CONSTRUCTION SUMMARY

Mountainview Heights 3 (G) - Russell Gardens Building Ltd.

LOT / PHASE	REG. PLAN #	HOUSE TYPE
314 / 3	62M-1266	Mountainash Five (4 Bedroom) Elev 3

**SCHEDULE "PE"
PURCHASER'S EXTRA**

FIRST FLOOR PLAN

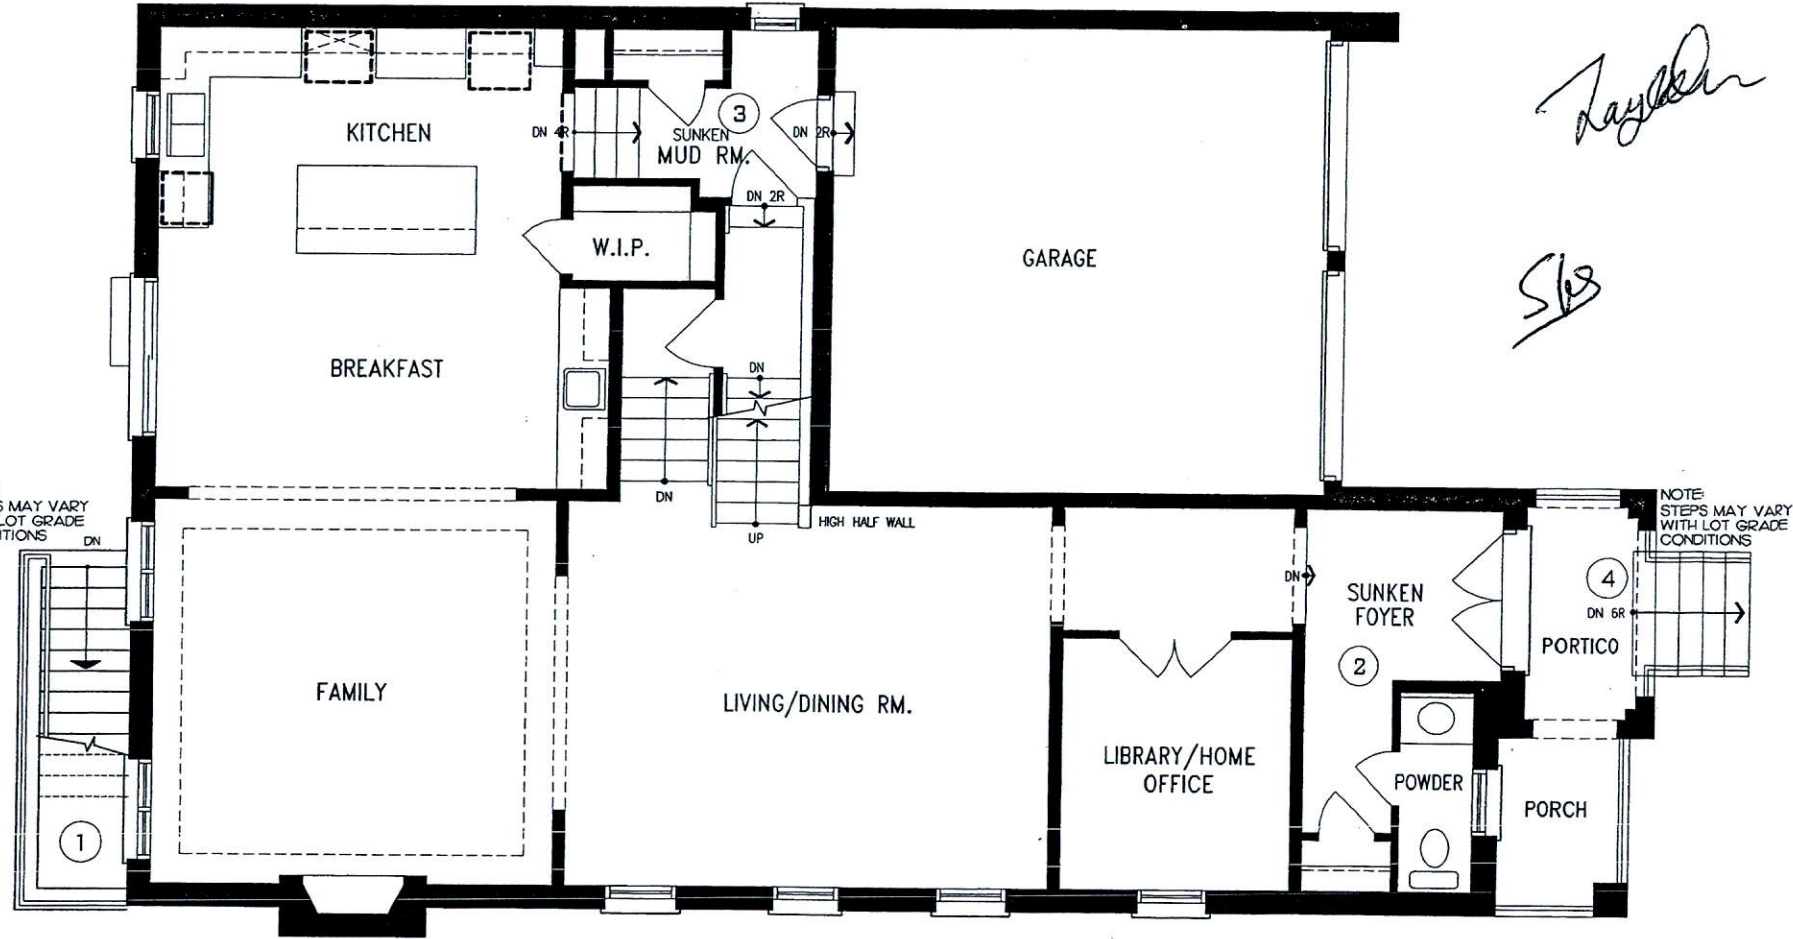
1. ADD EXTERIOR BASEMENT WALK-UP STAIRS TO REAR OF HOUSE.
2. SUNKEN FOYER AS REQUIRED BY GRADE
3. MUD ROOM - ADD EXTRA STEPS AS REQUIRED BY GRADE, REDESIGN CLOSET AS PER SKETCH, RELOCATE WINDOW
4. RECESSED STEP INTO PORCH AS REQUIRED BY GRADE

BASEMENT PLAN

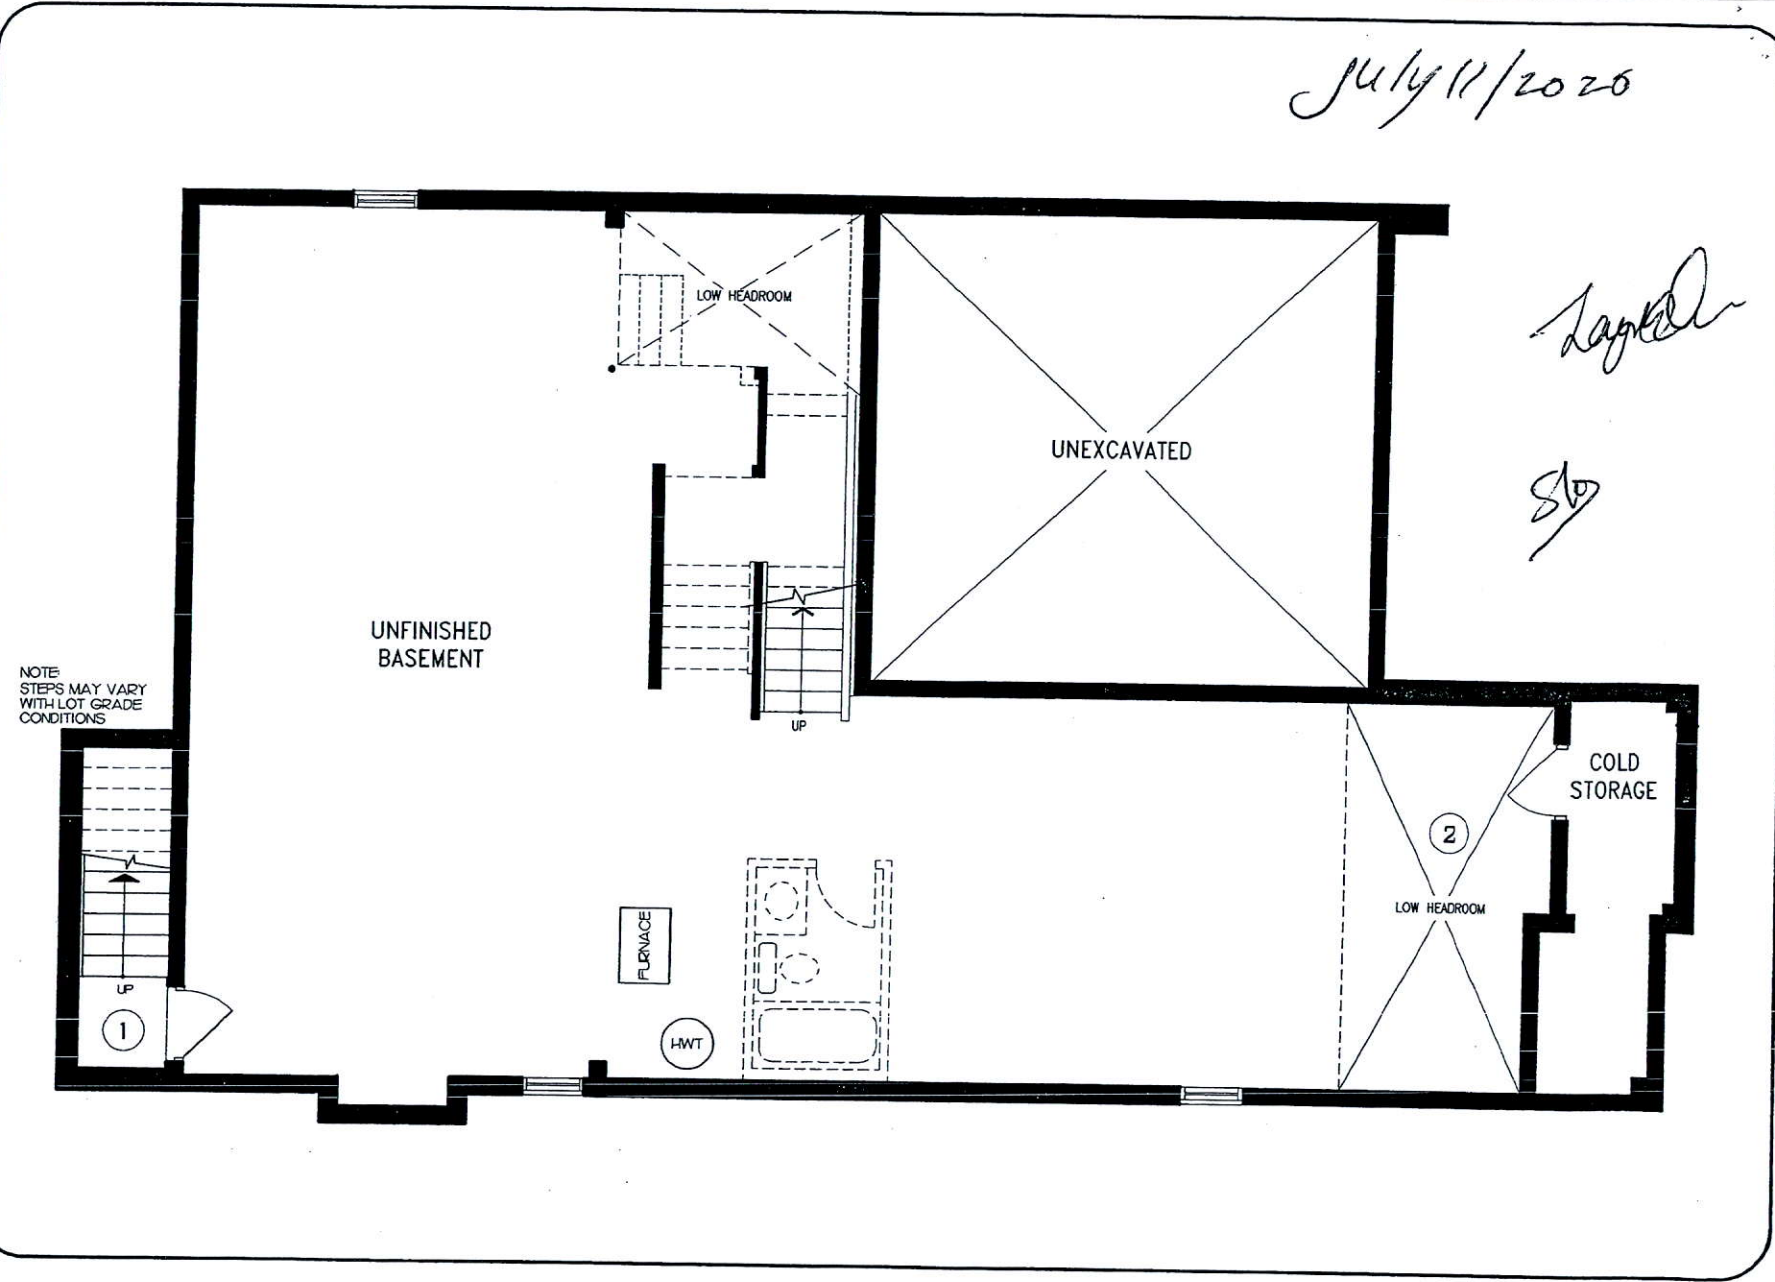
1. ADD EXTERIOR BASEMENT WALK-UP STAIRS TO REAR OF HOUSE.
2. LOW HEADROOM UNDER SUNKEN FOYER
